# FUNDAMENTALS SURVEY

## Example Fundamentals Survey

1

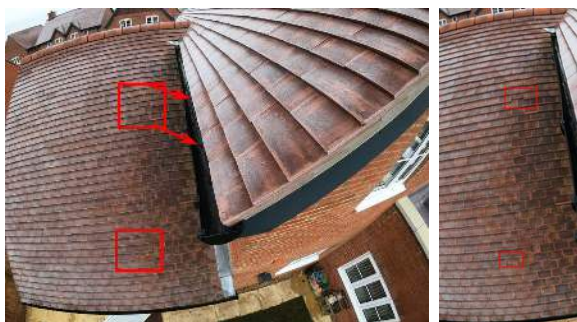
Personnel door, Sealant missing and gap requires filling to ensure water tightness and a neat appearance

5

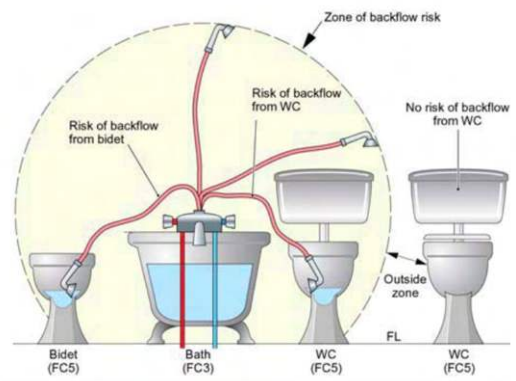
Gurgling noise heard from the bath waste when draining which is typically a vacuum issue, indicative of a blockage in the system. A plumber should attend to investigate the matter further

1

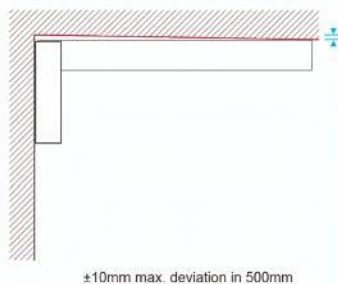
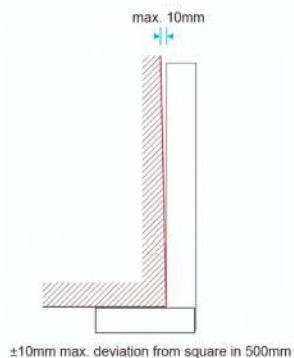
Wall is not square and noticeable by eye. Walls should be square within a maximum permissible deviation of  $\pm 10\text{mm}$  over 500mm, as per NHBC 9.1.3
